ADDENDUM NO. 1

PROJECT NO: 1110169

TITLE OF PROJECT: Visitor Center Repairs and HQ Restroom Replacement

FACILITY LOCATION: Monahans Sandhills State Park

C-03

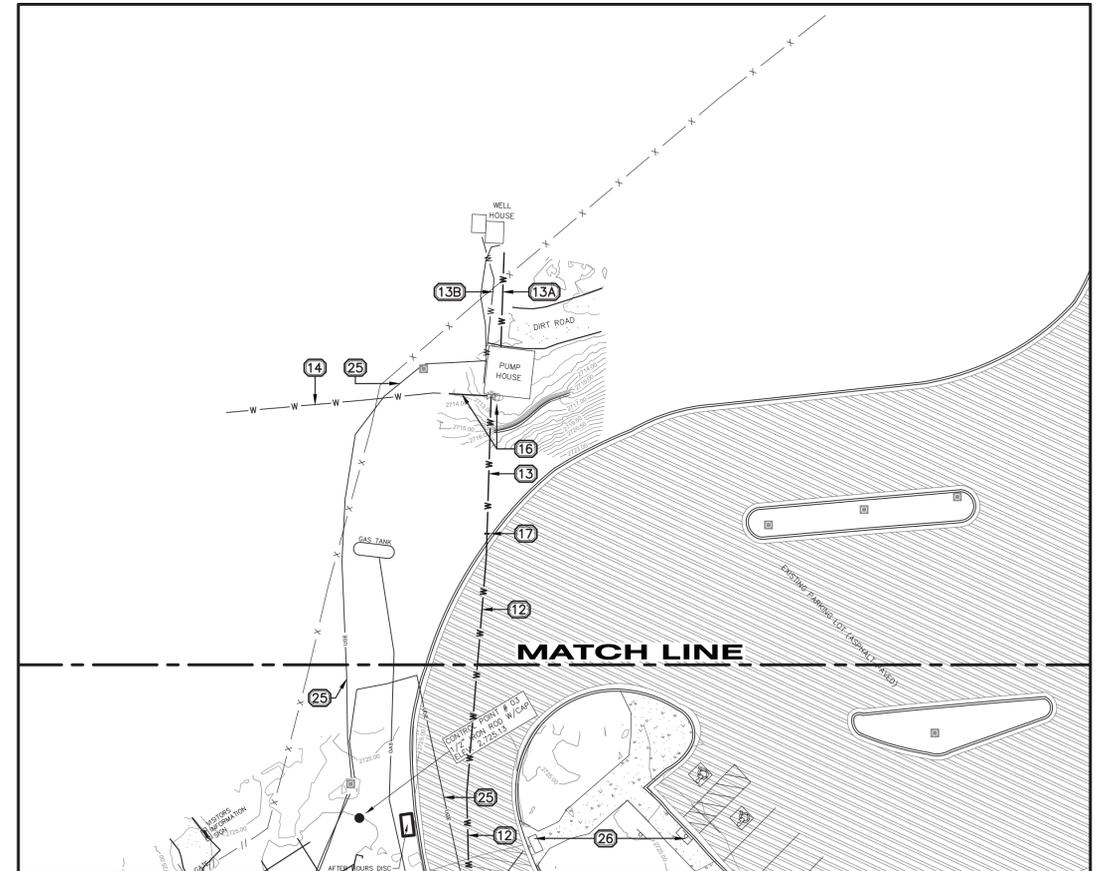
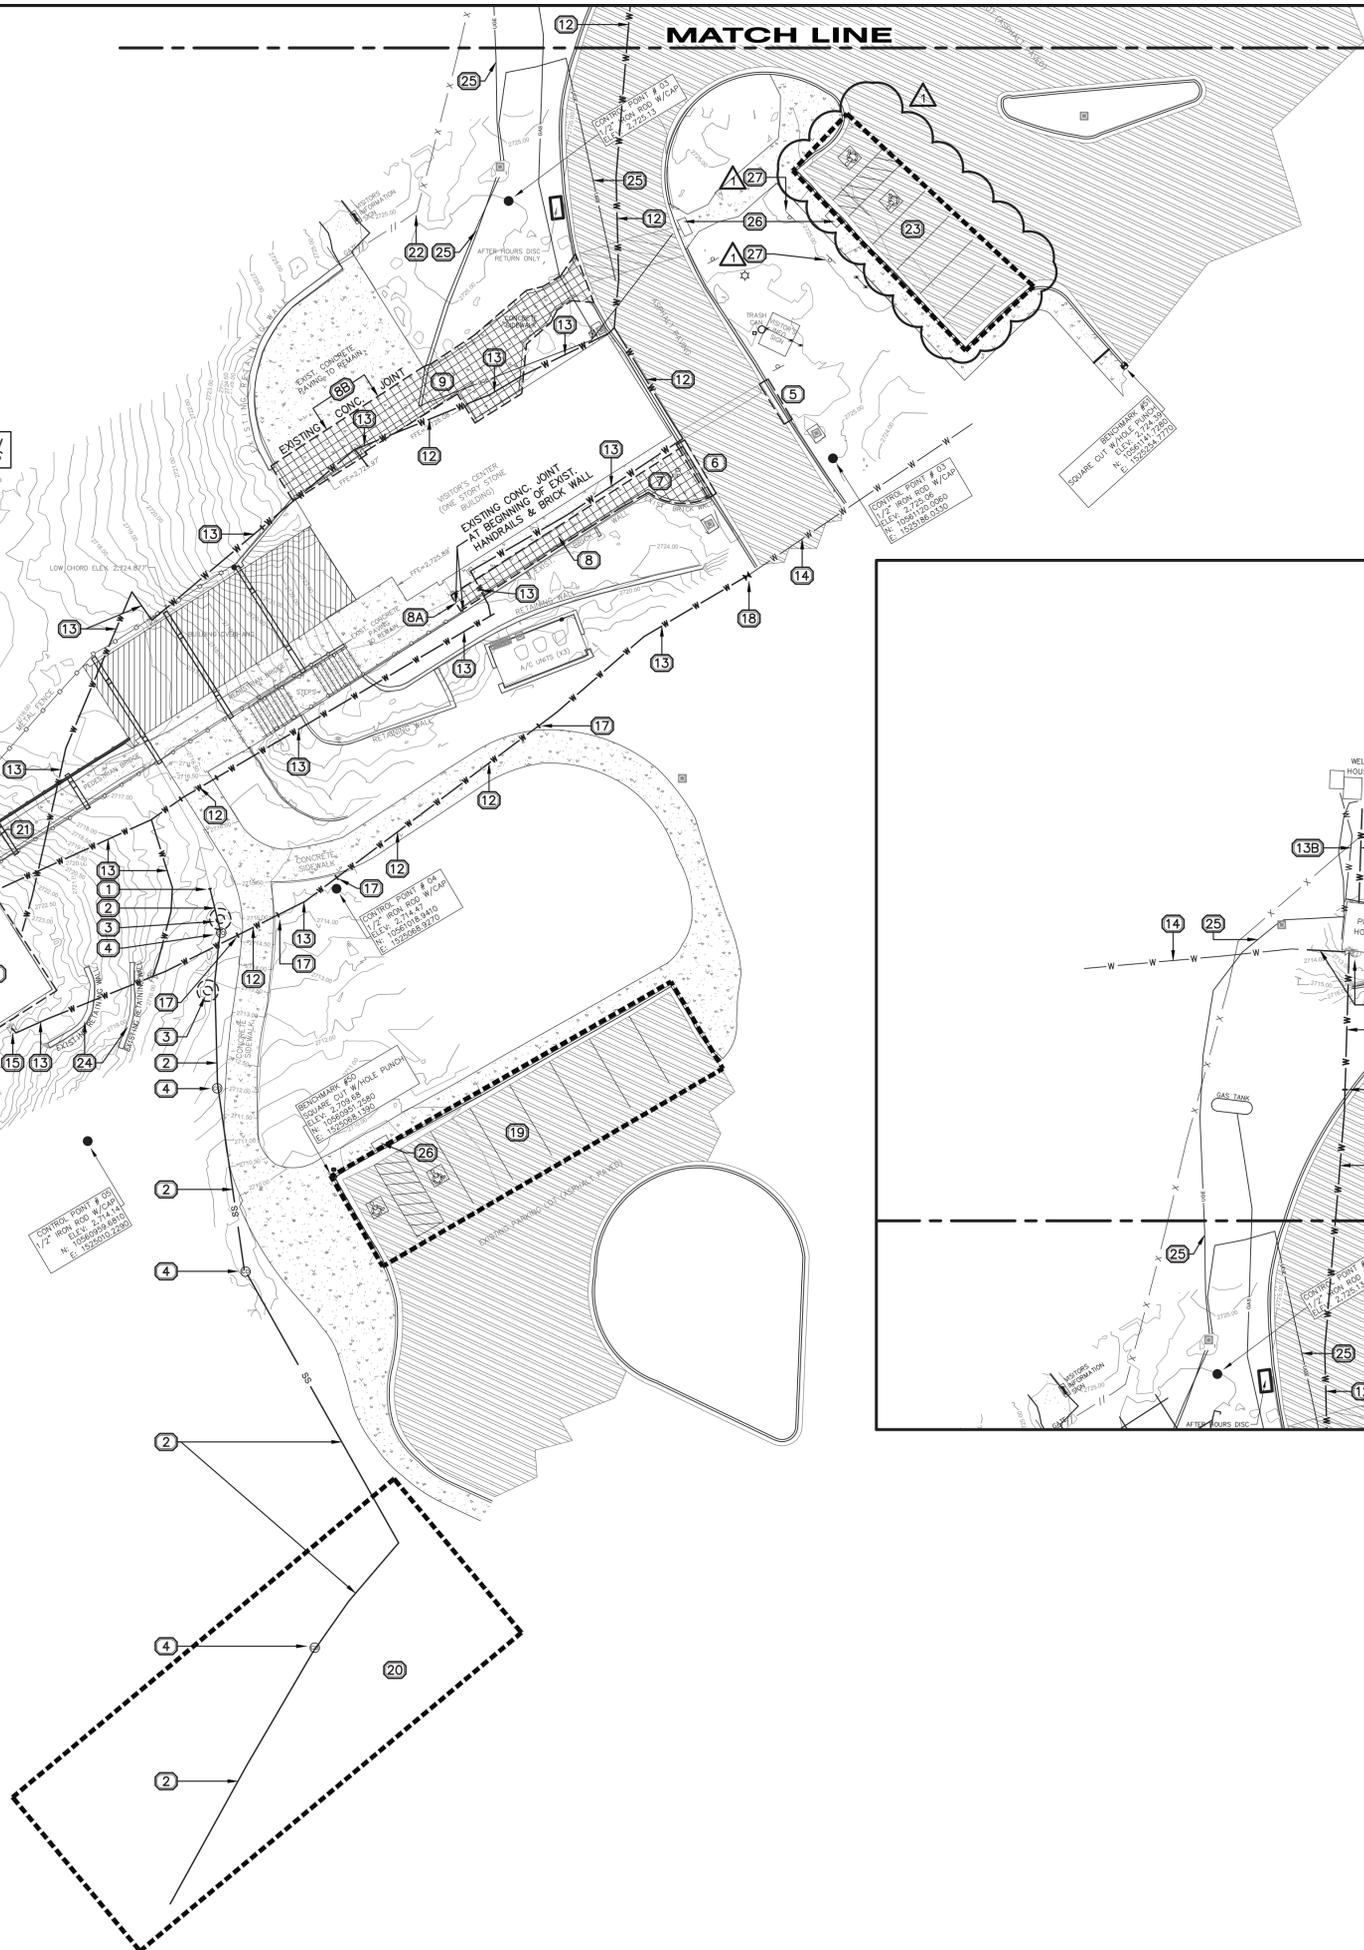
REVISED:
 ADD1 5/07/21
PARKING SPACES STRIPING TO BE REMOVED.
A.D.A. SIGNS TO BE REMOVED.

SHEET NUMBER
C-06

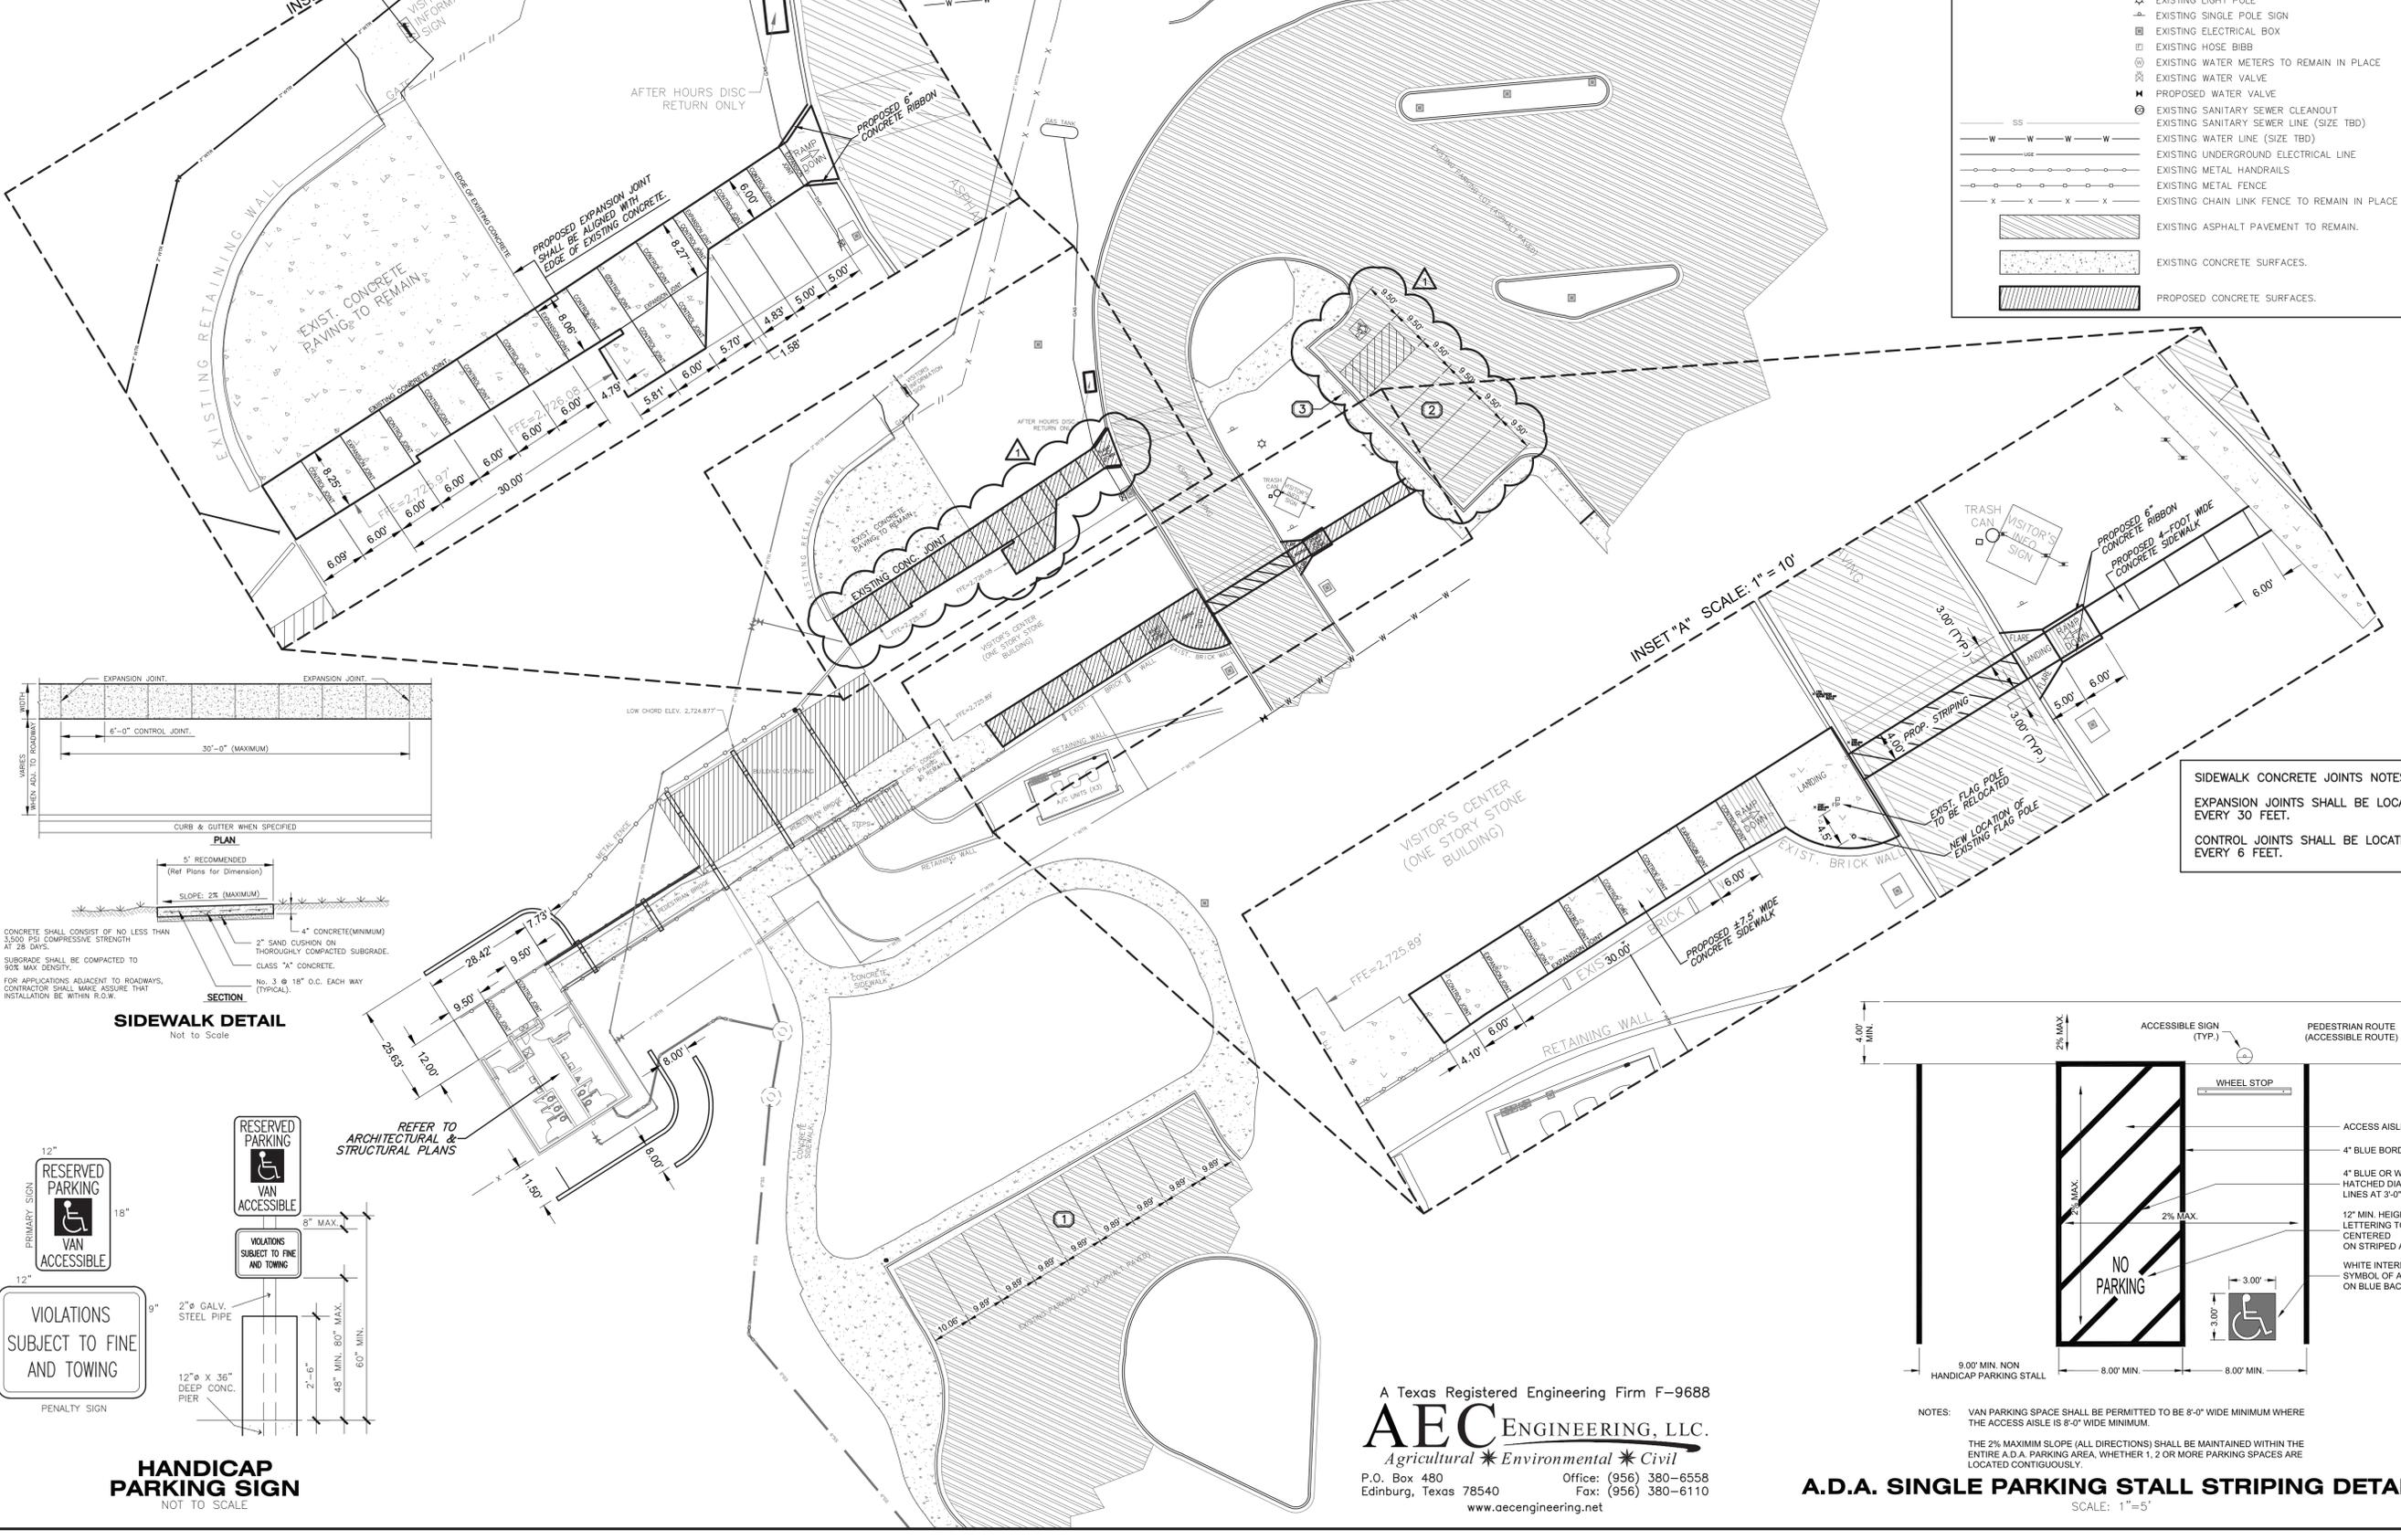
REVISED:
 ADD1 5/07/21
 SIDEWALK WAS STRAIGHTENED, GRADES REVISED TO MEET A.D.A. REQ.

PARKING SPACES RE-ARRANGED, A.D.A. SIGN ADDED.

SHEET NUMBER
C-07

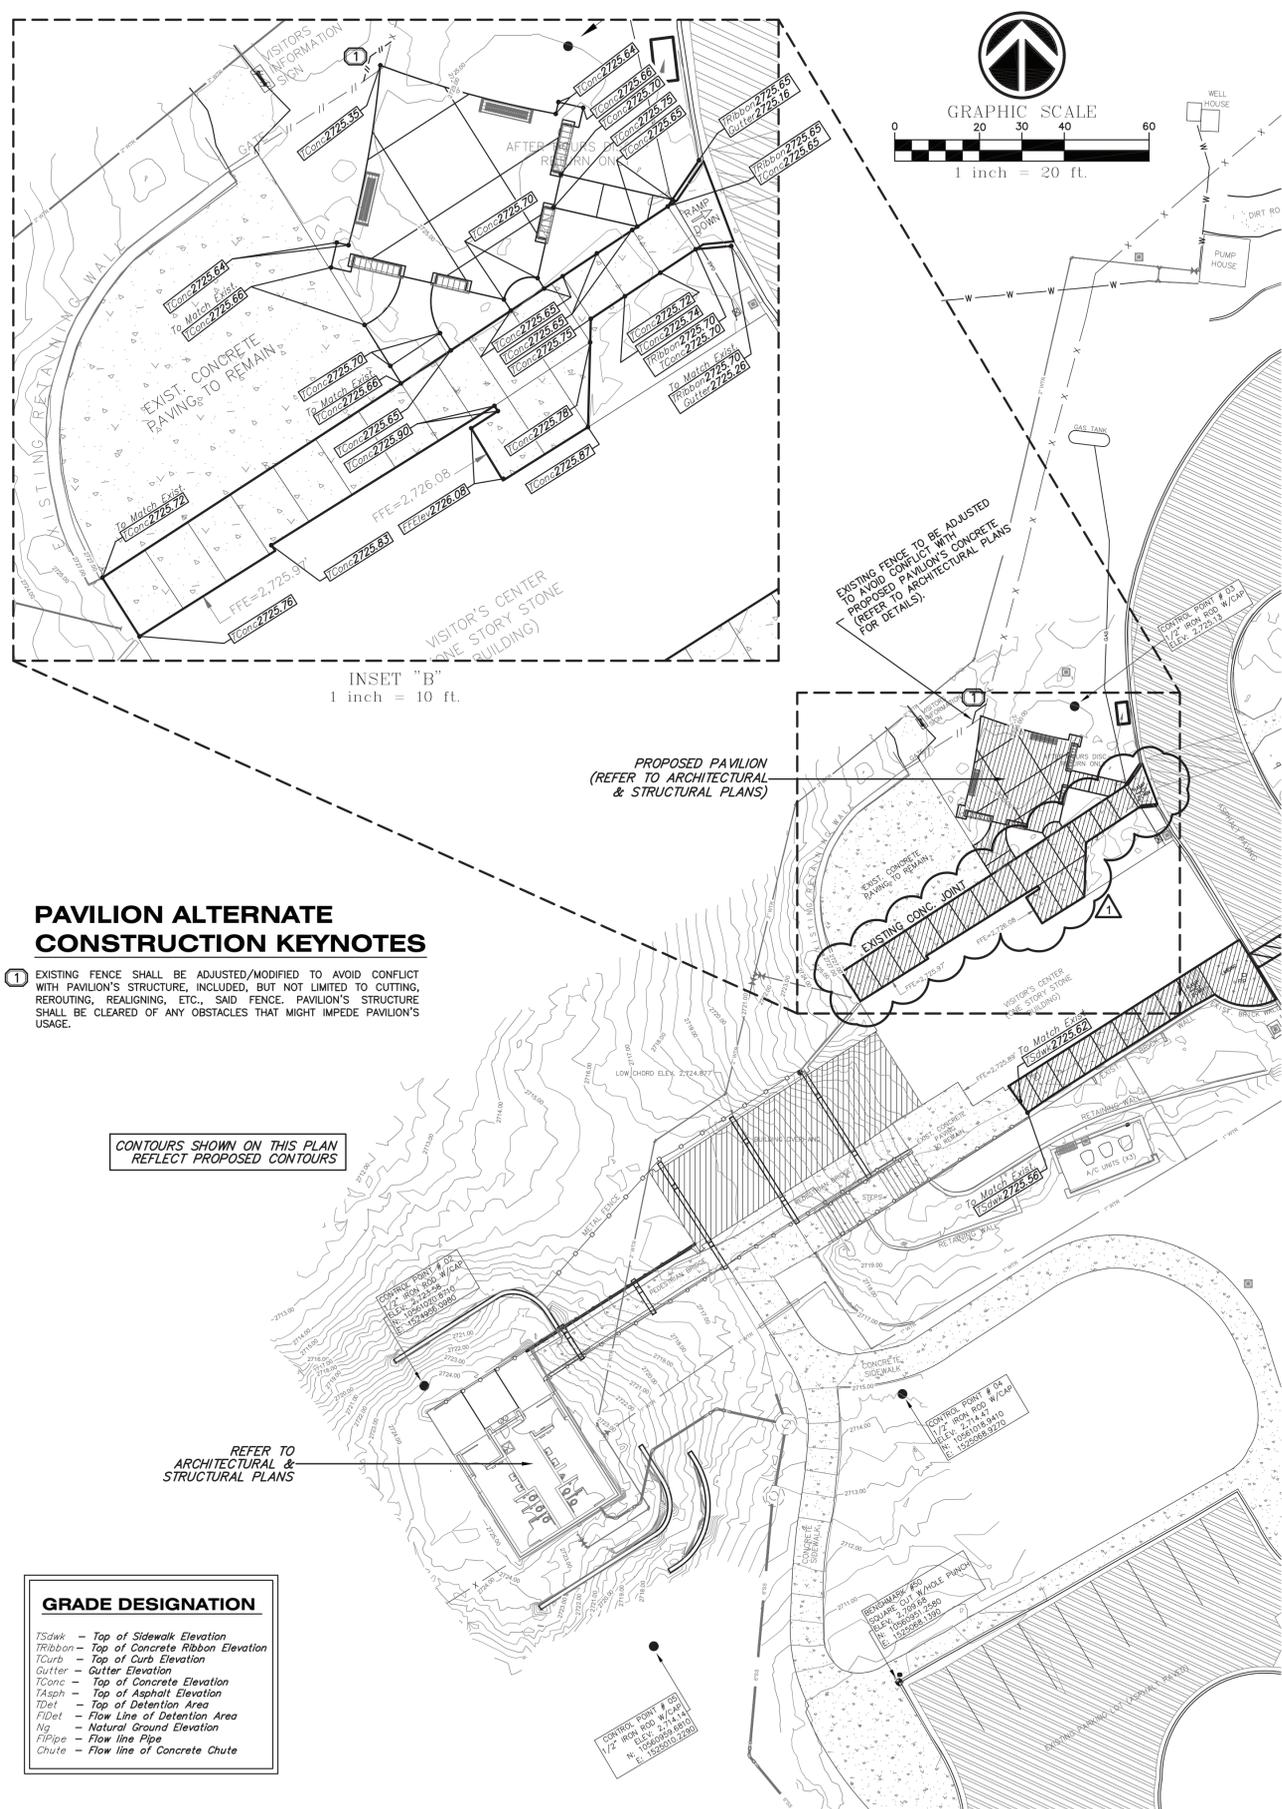
REVISED:
ADD1 5/07/21
SIDEWALK WAS STRAIGHTENED, GRADES REVISED TO MEET A.D.A. REQ.

PARKING SPACES RE-ARRANGED, A.D.A. SIGN ADDED.
